[Docket No. FAA-2006-25105; Directorate Identifier 2006-CE-33-AD; Amendment 39-14982; AD 2007-06-01]

Airworthiness Directives; Raytheon Aircraft Company Beech Models 45 (YT-34), A45 (T-34A, B-45), and D45 (T-34B) Airplanes

ACTION: Final rule.

PROBE LOCATING,
BUSHING TOOL

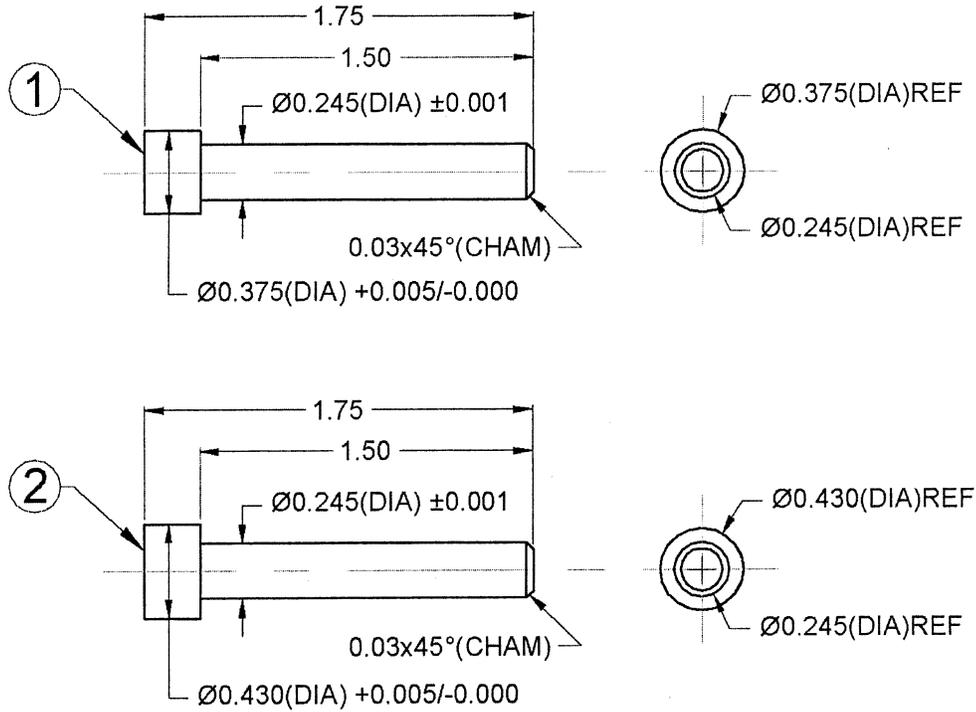
REVISIONS			
REV	DESCRIPTION	DATE	APPROVED
A	CHANGED TO BE MADE INTO TWO SEPERATE PARTS	3-10/05	D. LANGRETH
